Reference: P1730B

Subject: Westgate Industrial Estate – 253-267 Aldington Road, Kemps Creek (SSD-23480429)
Modification Transport Assessment

DOCUMENT INFORMATION
SWEPT PATH ASSESSMENT

FILE NAME AG1730B-01-v06.dwg	SHEET AG01
---------------------------------	---------------

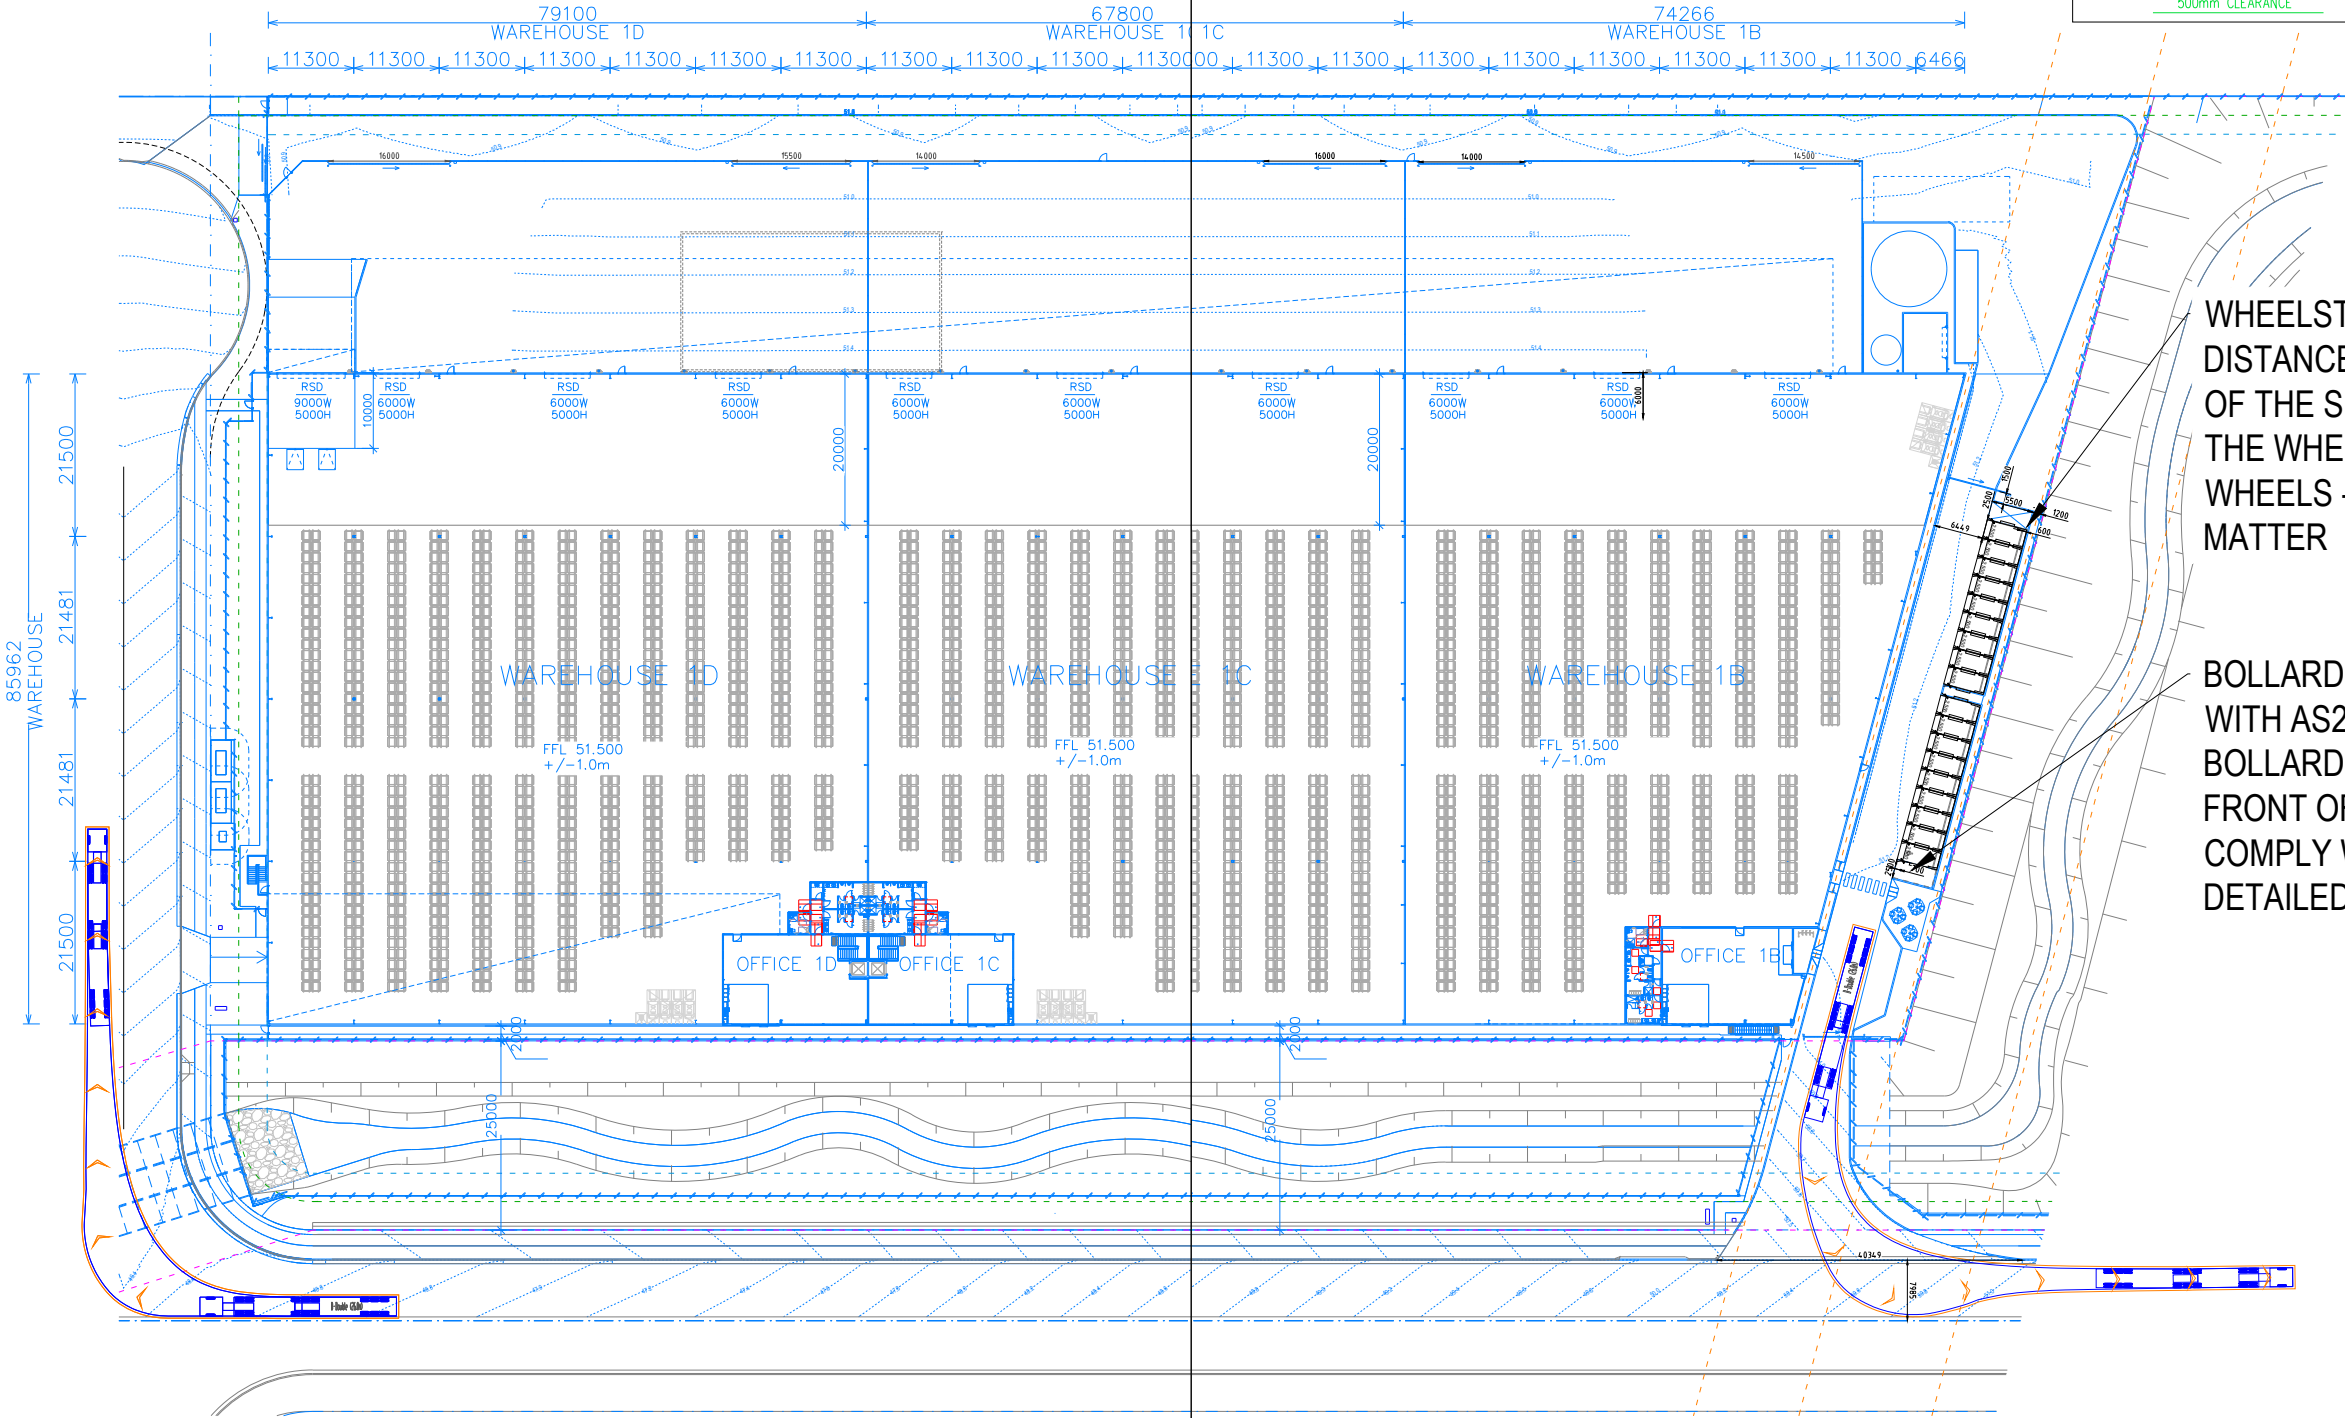
OPERATIONAL TRAFFIC MANAGEMENT
PLAN AND DETAILED BOOKING SYSTEM
REQUIRED TO ACCOMPANY B-DOUBLE
SIDE-LOADING ACCESS

WHEELSTOPS ARE TO BE 1.1M
DISTANCE FROM THE FRONT
OF THE SPACE TO THE SIDE OF
THE WHEELSTOP FACING THE
WHEELS - DETAILED DESIGN
MATTER

BOLLARD LOCATION COMPLIES
WITH AS2890.6:2009 - MOVE
BOLLARD TO BE 750MM FROM
FRONT OF SPACE AS SHOWN TO
COMPLY WITH AS2890.6:2022 -
DETAILED DESIGN MATTER

SHEET
AG02

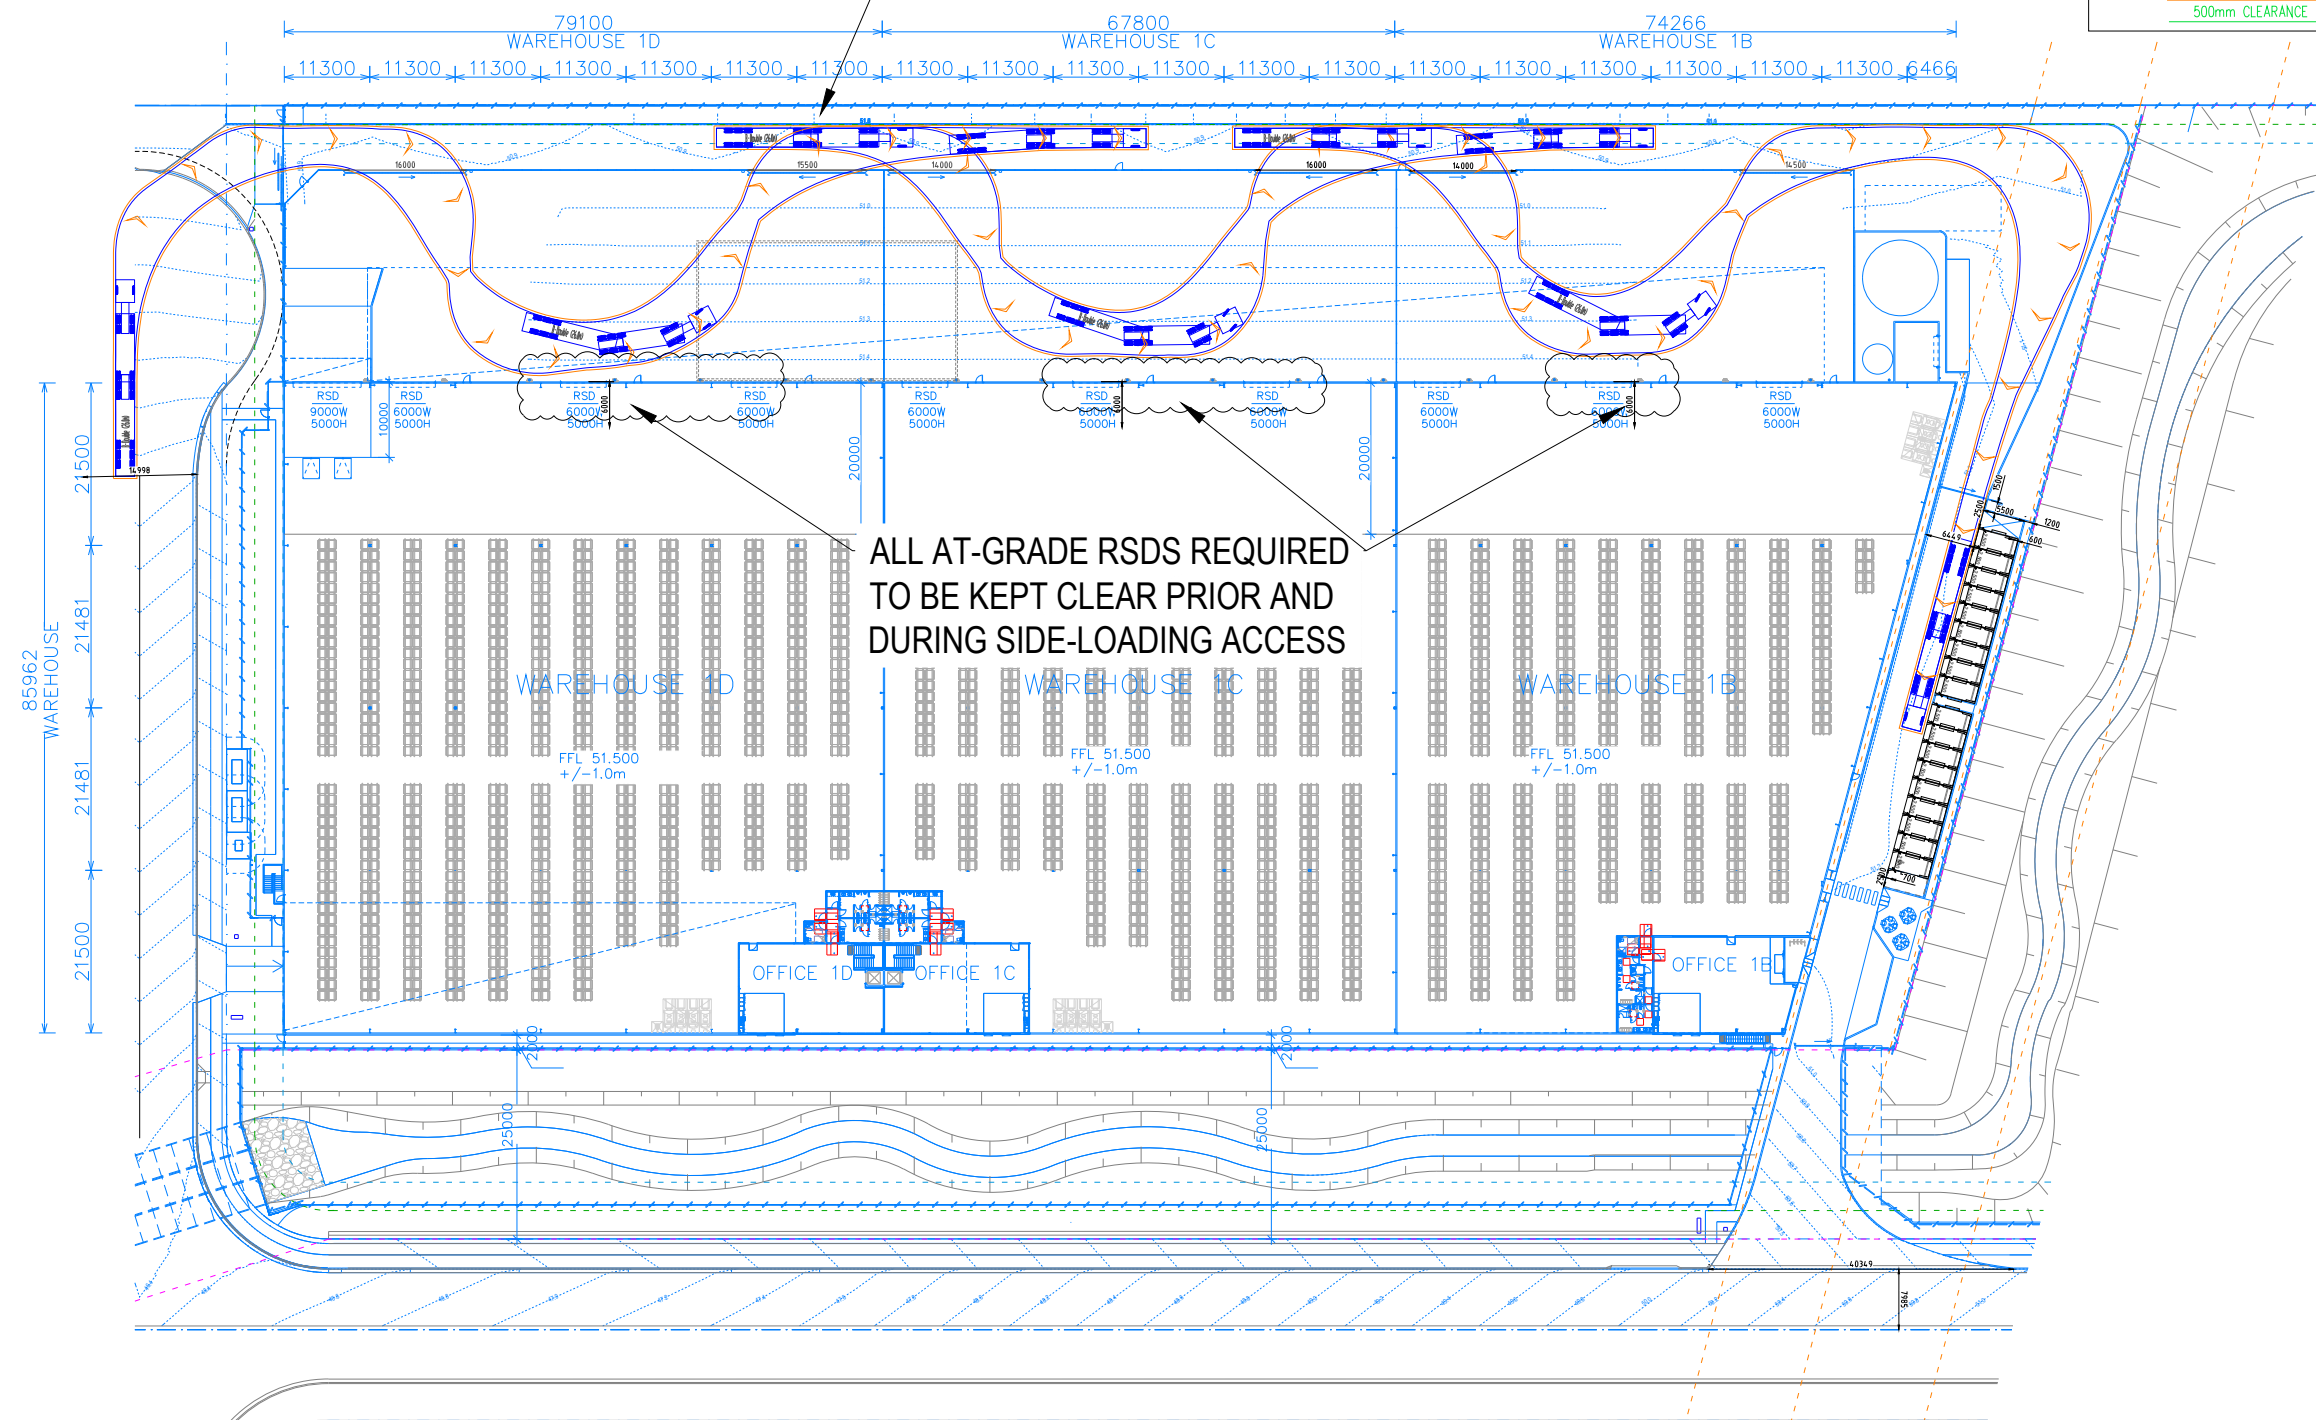
CONVEX MIRRORS TO BE PROVIDED TO
SUPPORT EXIT MOVEMENTS AS PART OF
SIGNAGE AND LINE-MARKING PLAN
ACCOMPANYING OTMP

ALL AT-GRADE RSDS REQUIRED
TO BE KEPT CLEAR PRIOR AND
DURING SIDE-LOADING ACCESS

DOCUMENT INFORMATION		 Suite 17.02, Level 17, 1 Castlereagh St Sydney NSW 2000 info@asongroup.com.au
SWEPT PATH ASSESSMENT		
FILE NAME	SHEET	
AG1730B-01-v06.dwg	AG03

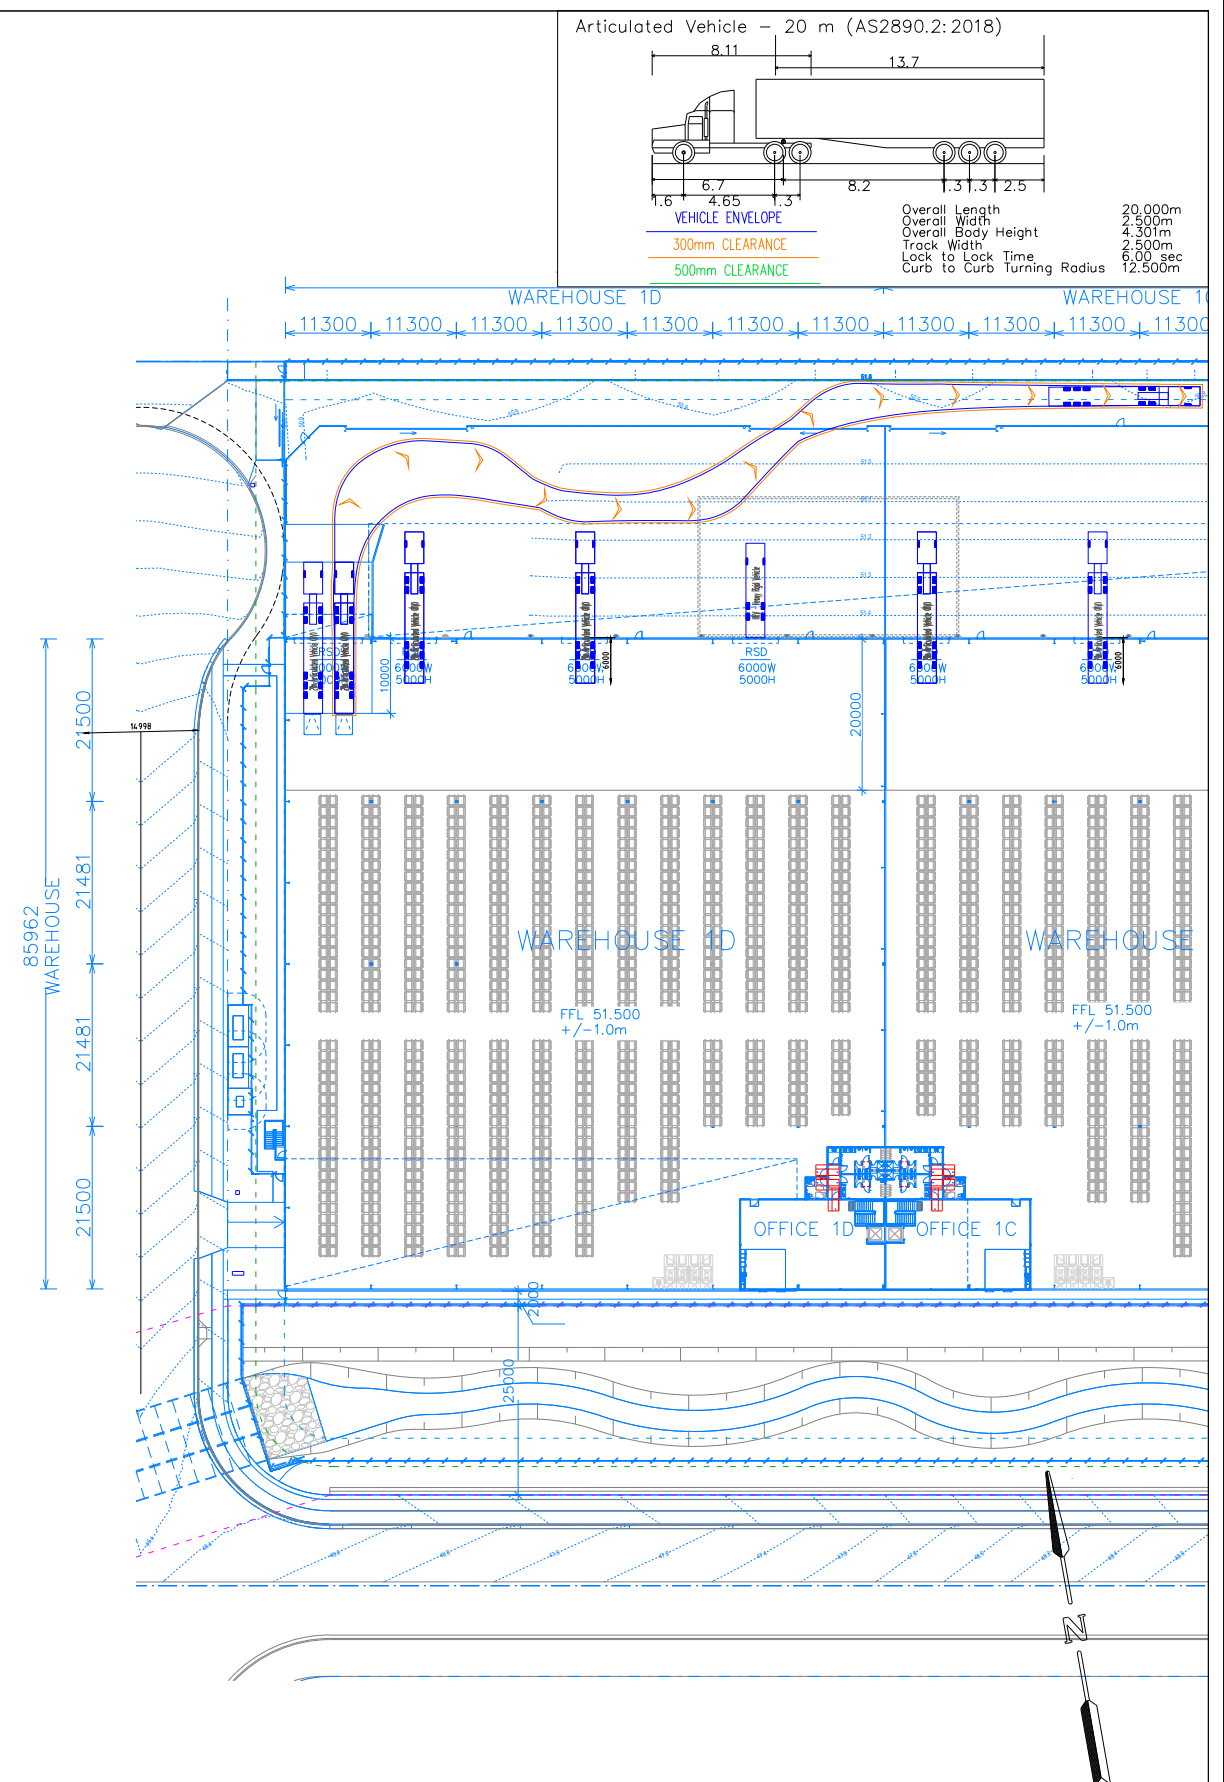
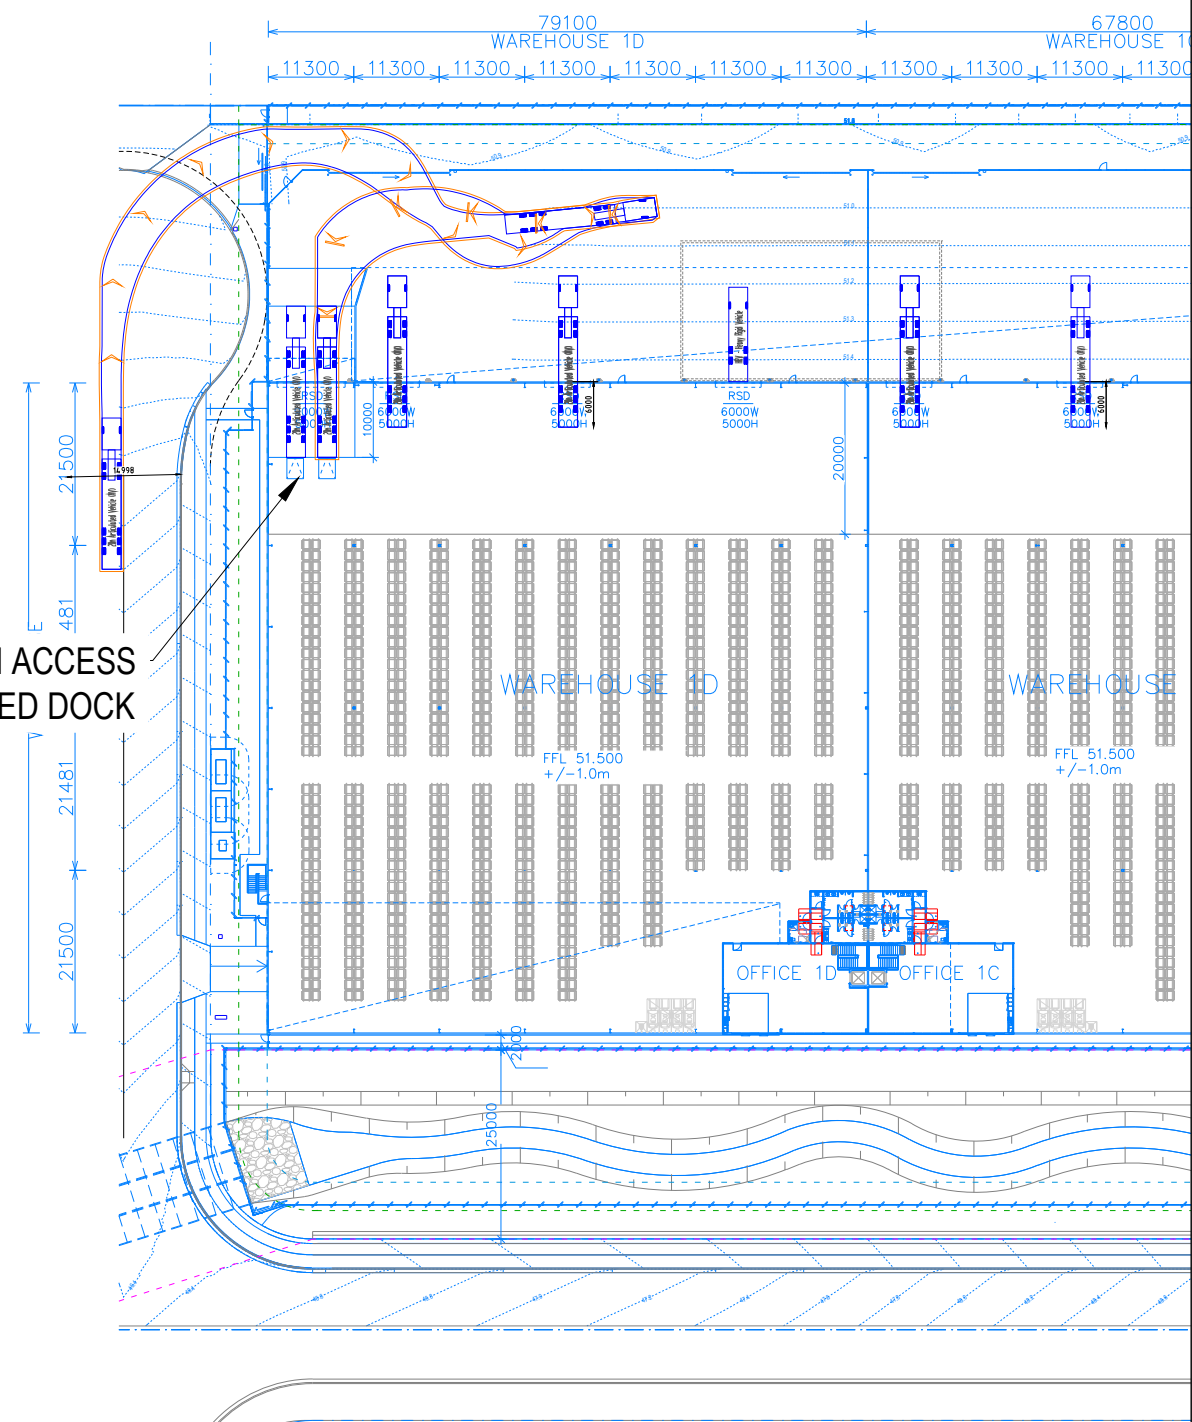
6 METRES OF INTERNALLY
LOADING ASSUMED FOR AV

EASTMOST RSDs
RESTRICTED TO 12.5M HRV

CONVEX MIRRORS TO BE PROVIDED TO
SUPPORT EXIT MOVEMENTS AS PART OF
SIGNAGE AND LINE-MARKING PLAN
ACCOMPANYING OTMP
